CITY OF PORTLAND

This is to certify that Mesden Llc /Daigle Construction has permission to Install Roof top decks AT 24 Brackett St

Permit No: 05-0572 **PERMIT ISSUED** SBL: 658 FQ13001

ROOF TOP DECK AND HOT TUB SUPPORT

SECTION
1/4" = 1'-0"

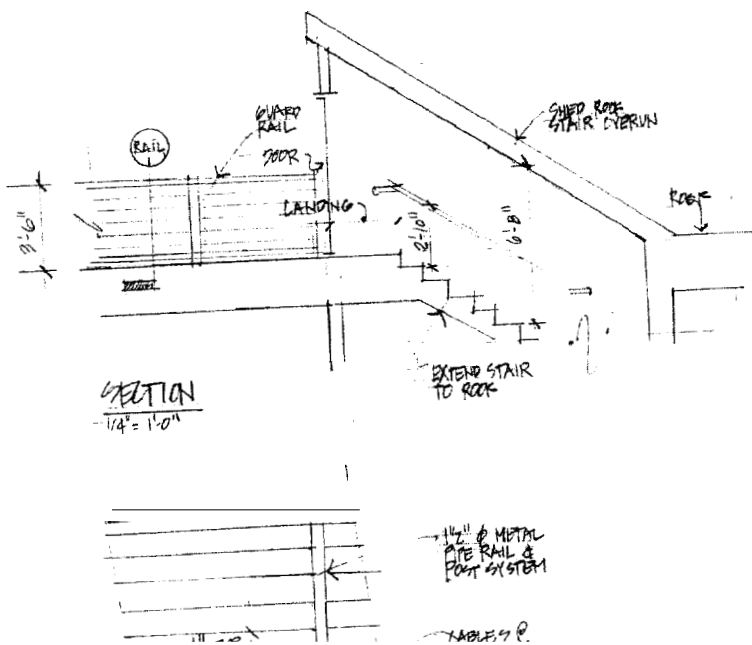
May not be completely enclosed
- No roof S

ROOF TOP DECK & HOT TUB SUPPORT
SECTIONS & DETAILS

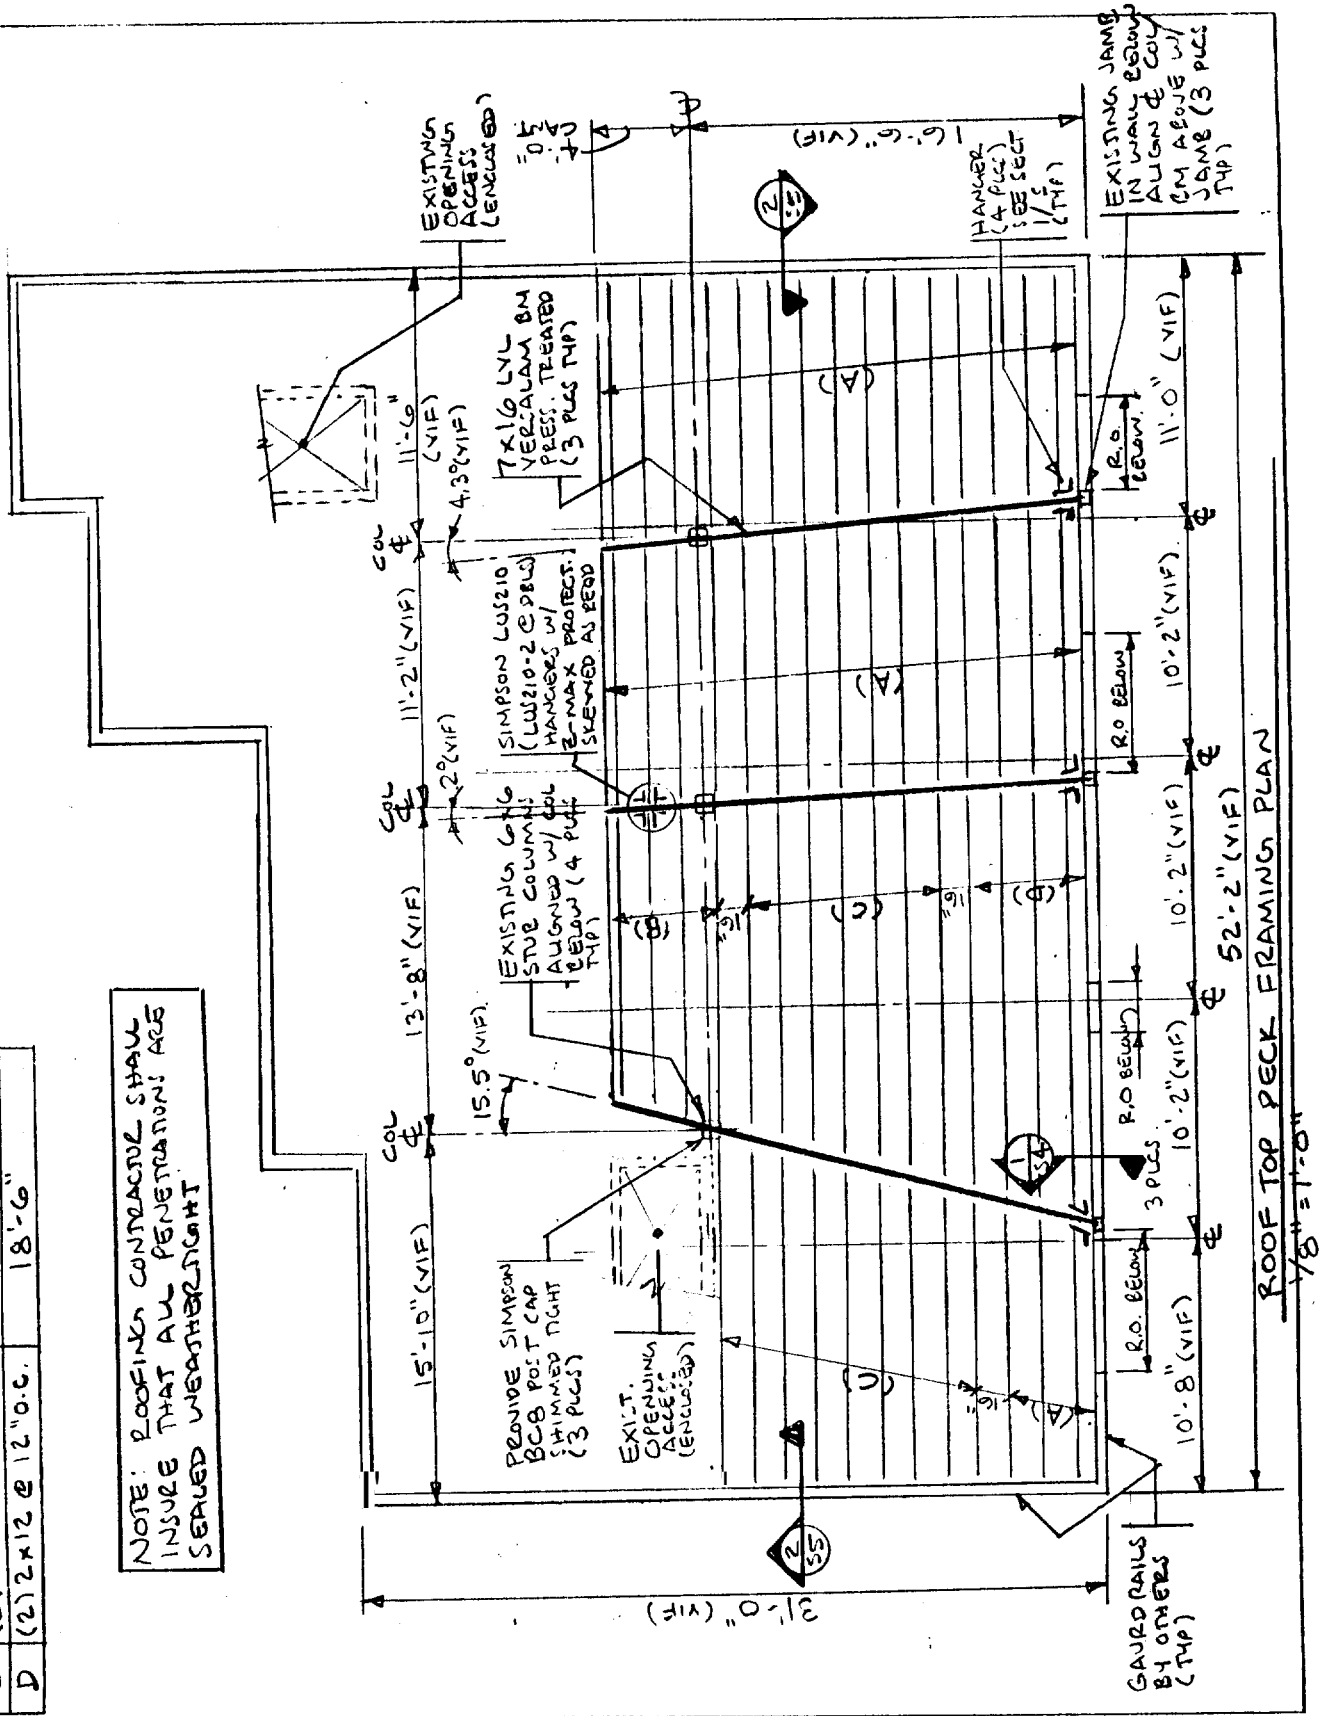
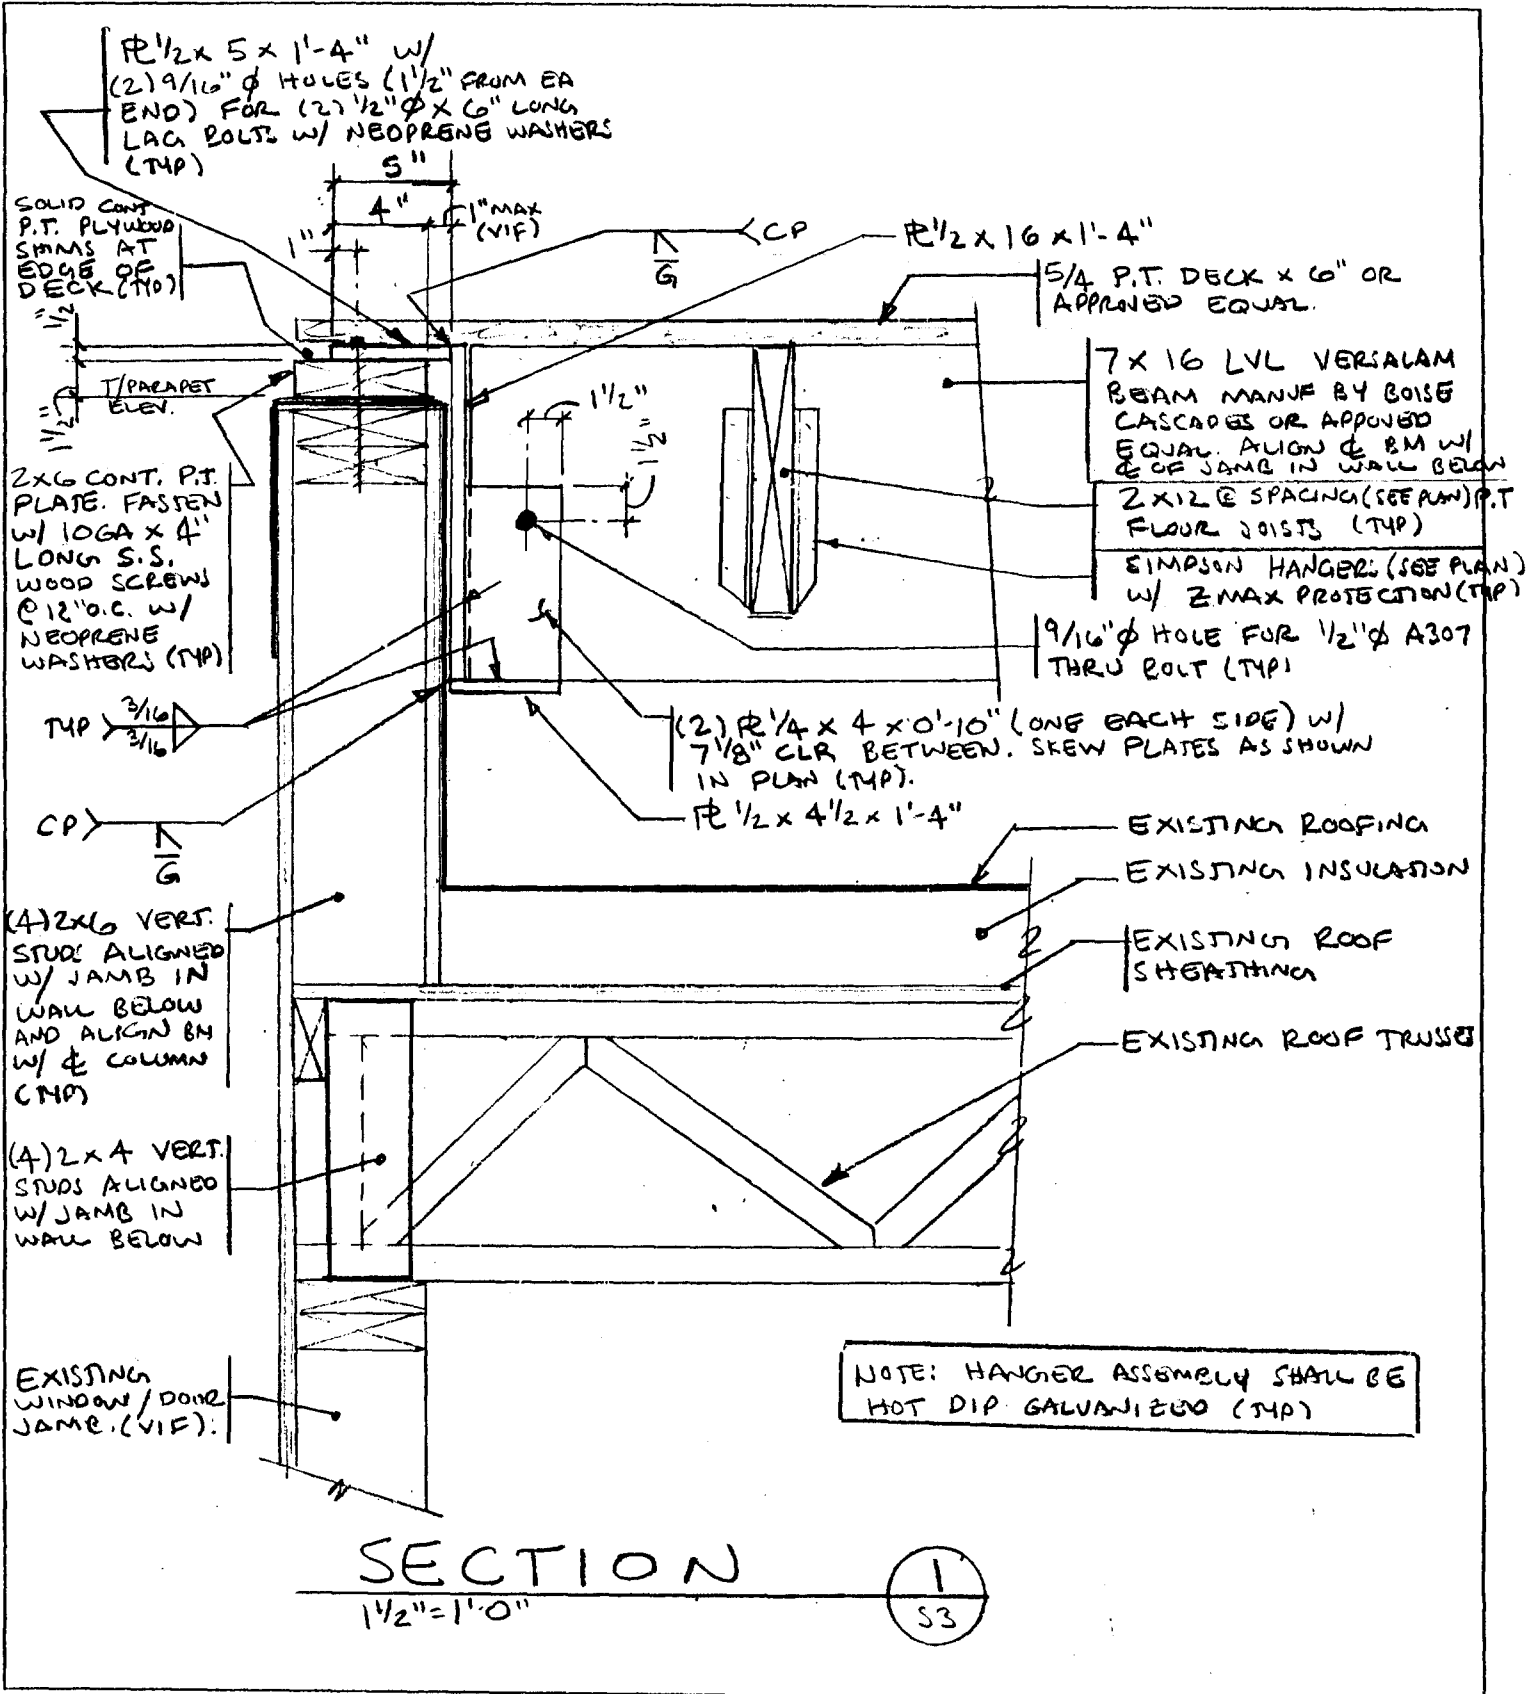
6/16/2005-mjn: Need guard design and better detail of how the roof stairs are protected and connected. Left a message w/ Joe Leisure

8/17/2005-mjn: Guard details not submitted, also special inspection of the framed product is required. Left message with Joe Leisure and New Owner??
